MODIFICATION BULLETIN NO. LHO-001ISSUED ON Sep. 14, 1994

Model	LHO (MV715)			Date of Modification	
Modified Article				Execution Date	
Reason for Modification	<input type="checkbox"/> Parts catalog correction <input type="checkbox"/> Vendor change	<input type="checkbox"/> To meet standards () <input checked="" type="checkbox"/> Part standardization	<input type="checkbox"/> To facilitate assembly <input type="checkbox"/> To improve reliability <input type="checkbox"/> Other	After the old part has become out of stock.

23. ELECTRICAL SECTION.4

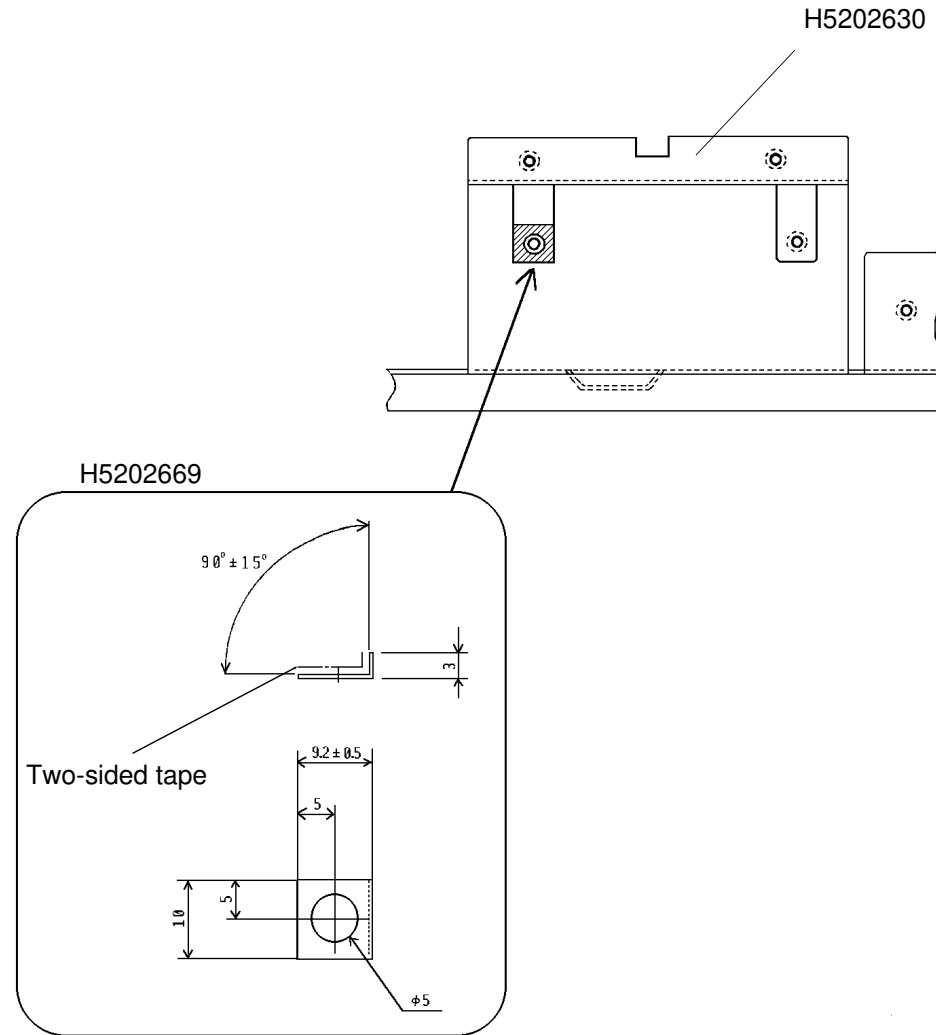
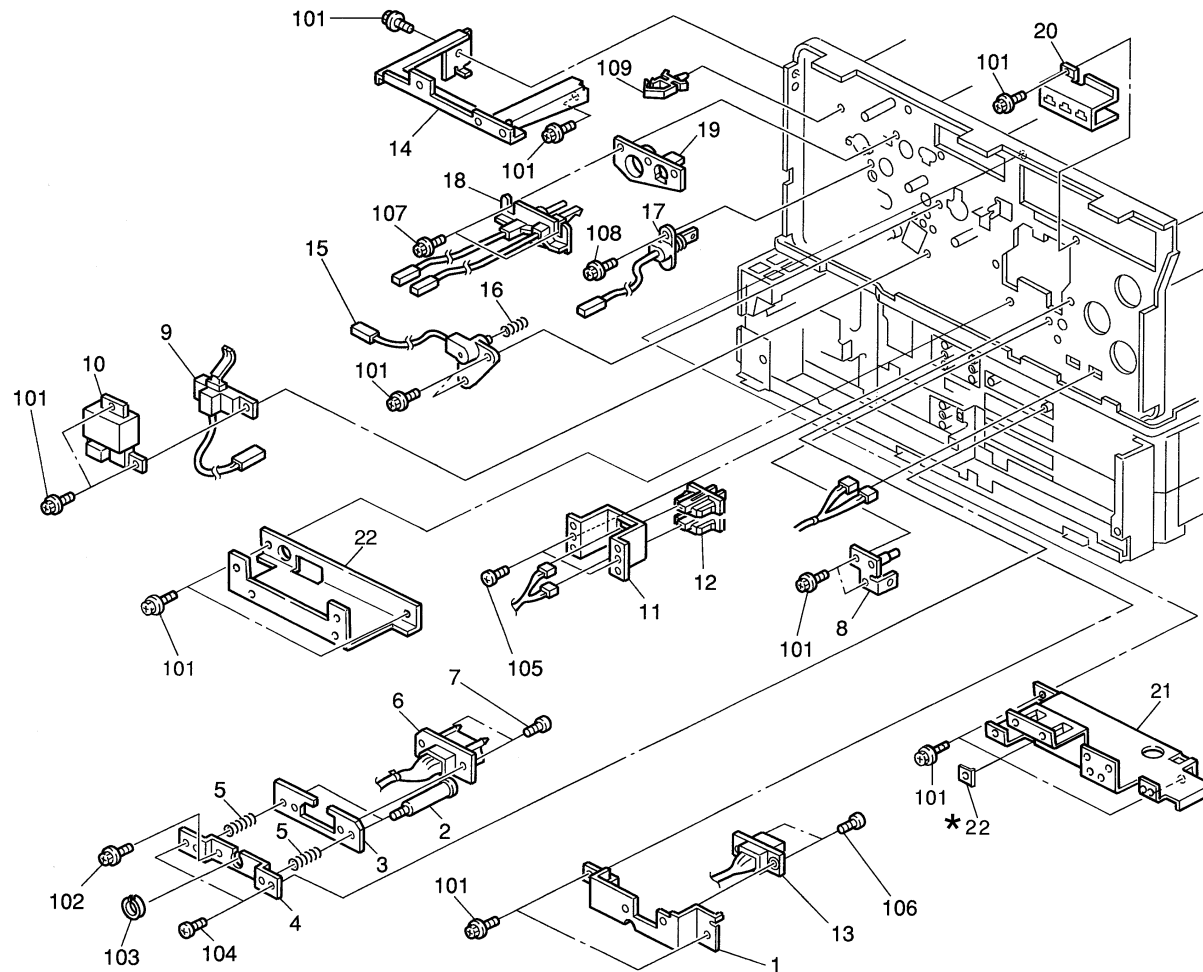
Model	LHO					Date of Modification	
Modified Article	Insulating Sheet-MBU					Execution Date	
Reason for Modification	<input type="checkbox"/> Parts catalog correction <input type="checkbox"/> To meet standards () <input type="checkbox"/> To facilitate assembly <input type="checkbox"/> Vender change <input type="checkbox"/> Part standardization <input checked="" type="checkbox"/> To improve reliability <input type="checkbox"/> Other					A120-22: 8915060328 A120-27: U8050600001 A120-30: F0650600001	
<p>To prevent the pins of the socket for IC7 (EP-ROM) from being short-circuited, an insulating sheet has been newly added onto the FCU upper shielding plate (P/N H5202630) as shown on the next page.</p>							
Old Part No.	New Part No.	Description	Q'ty Used Old → New	Interchange- ability	Remarks	Parts Catalog	
						Index No.	Page
	H5202669	Insulating Sheet - MBU	0 → 1			* 22	47
<div style="text-align: right;">* : New Index</div> <div style="text-align: right; margin-top: 20px;"> M. Iwasa Manager 2nd T.S.Sec. Int'l Marketing Group </div>

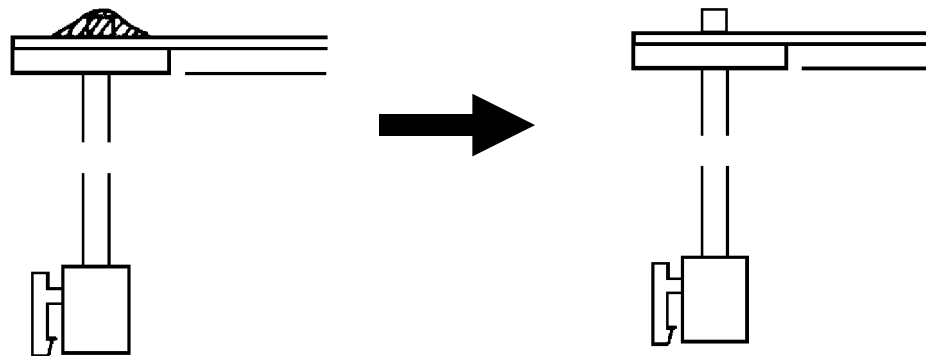
Model	LHO			Modification Schedule	
Modified Article	Scanner section2			April 1996	
Reason for Modification	<input type="checkbox"/> Parts catalog correction <input type="checkbox"/> Vender change	<input type="checkbox"/> To meet standards () <input checked="" type="checkbox"/> Part standardization	<input type="checkbox"/> To facilitate assembly <input type="checkbox"/> To improve reliability <input type="checkbox"/> Other

Old Part No.	New Part No.	Description	Q'ty Used Old → New	Interchange- ability	Remarks	Parts Catalog	
						Index No.	Page
H520 5003H	H520 5003J	Exposure Lamp Harness	1 → 1	O / O		23	21

PRINTER OPTION – 115V (H144)

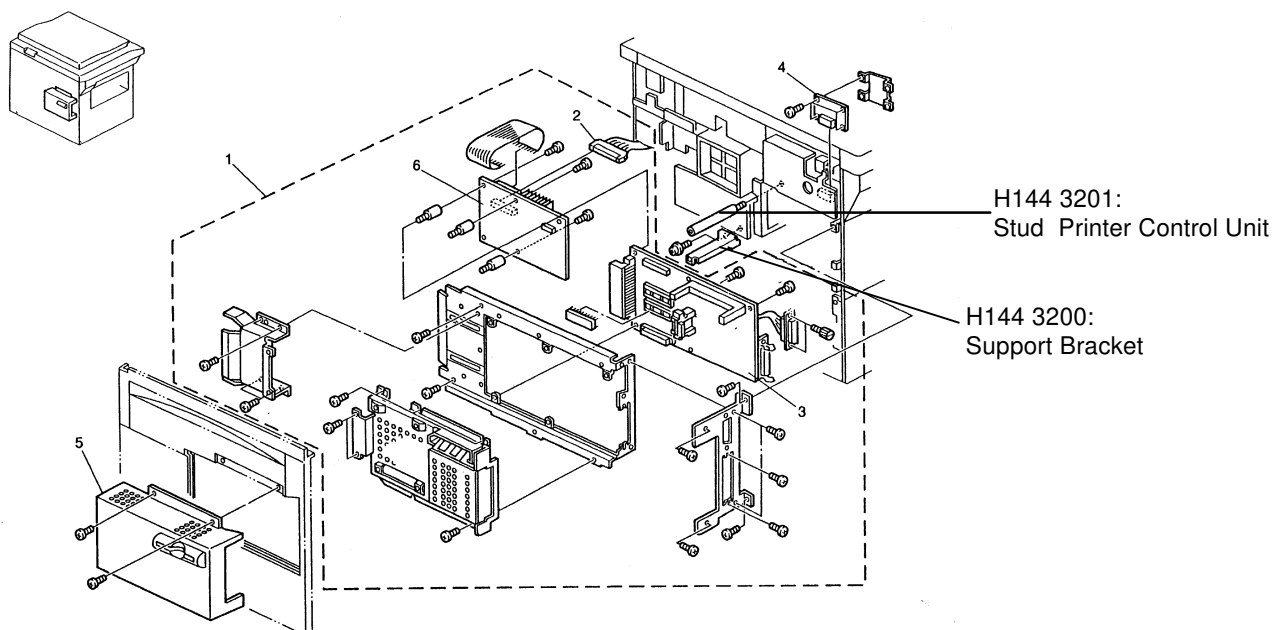
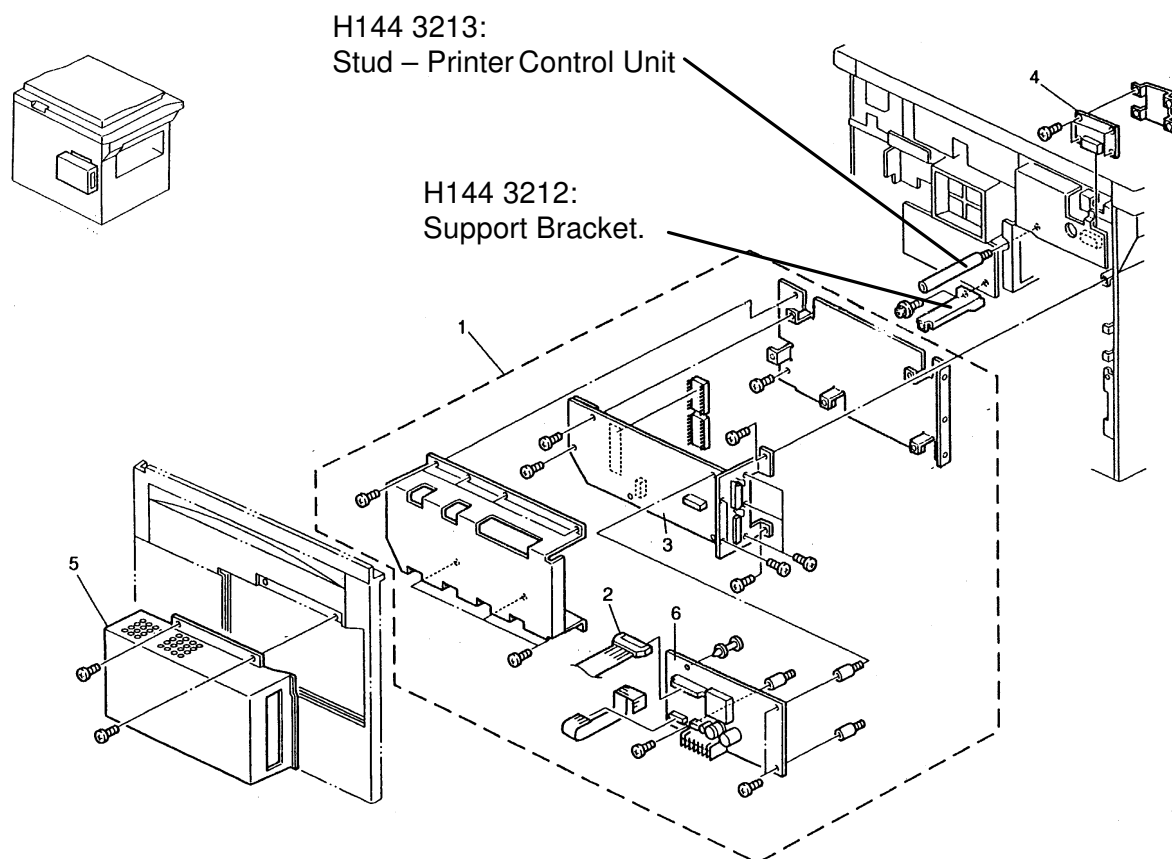
The illustration has changed as shown below.

Model: LHO		Date: 31-Jul-97	No: 037
Modified Article: Printer option		Prepared by: K.Moriizumi	
From: QAC 2nd Field Information Dept.			
Reason for Modification:	<input checked="" type="checkbox"/> Parts catalog correction <input type="checkbox"/> Vendor change <input type="checkbox"/> To meet standards <input type="checkbox"/> To facilitate assembly <input type="checkbox"/> To improve reliability () <input type="checkbox"/> Part Standardization <input type="checkbox"/> Other		
Modification Schedule

Old part number	New part number	Description	Qty	Int	Page	Index	Note
	H144 3200	Support Bracket	1		48		
	H144 3201	Stud – Printer Control Unit	1		48

Old part number	New part number	Description	Qty	Int	Page	Index	Note
	H144 3212	Support Bracket	1		50		
	H144 3213	Stud – Printer Control Unit	1		50
